Safety Recall Trucks

Date	Group.	No.	Page
06.14	SC0378		1(4)

Rear Conspicuity Treatment
CXU

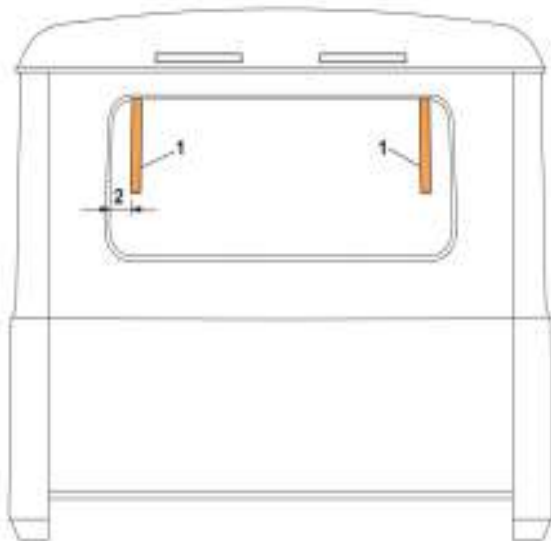
Mack Trucks Inc. has determined that the vertical white conspicuity reflectors on the back of the cab of certain CXU model vehicles may be blocked by the exhaust and air tank. As a result, a non-compliance with U.S. and Canada Motor Vehicle Safety Standard 108, which states “no more than 25% of their cumulative area may be obscured by vehicle equipment as determined in a rear orthogonal view,” may exist. The safety risk is the back of the truck-tractor may be less visible when operating without a trailer in the dark.

To address these concerns, MACK will update trucks to comply with U.S. and Canada Motor Vehicle Safety Standard 108, by applying new reflectors to the rear window. Follow the procedure outlined in this document.

1. Secure the vehicle for service by parking it on a flat level surface, applying the parking brake, chocking the rear wheel, and placing the transmission in neutral.
2. Disconnect all cables from the negative (ground) and positive battery terminals to prevent personal injury from electrical shock and prevent damage to electrical components.
3. Locate the correct installation sites for the new reflectors.

1. Reflectors (Part Numbers 25160014 or 82934870)
2. Dimension from inside edge of window seal, 64 mm [2.5 in.]
4. Clean the reflector mounting surface. The surface must be clean and dry before the application of reflectors. Isopropyl alcohol or similar may be used to ensure surface cleanliness.

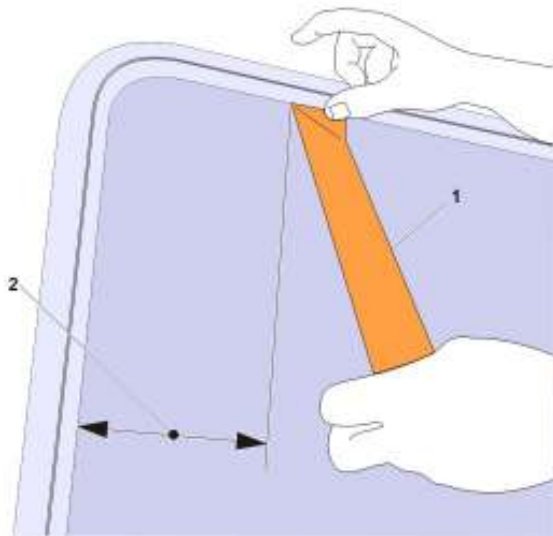
6. Place one end of the reflector against the rubber window seal (horizontal), as shown. Press lightly while holding the rest of the reflector away from the vehicle's surface.

1. Reflector

2. Dimension from inside edge of window seal, 64 mm [2.5 in.]

7. Press the reflector onto the surface, applying consistent pressure across its entire length.
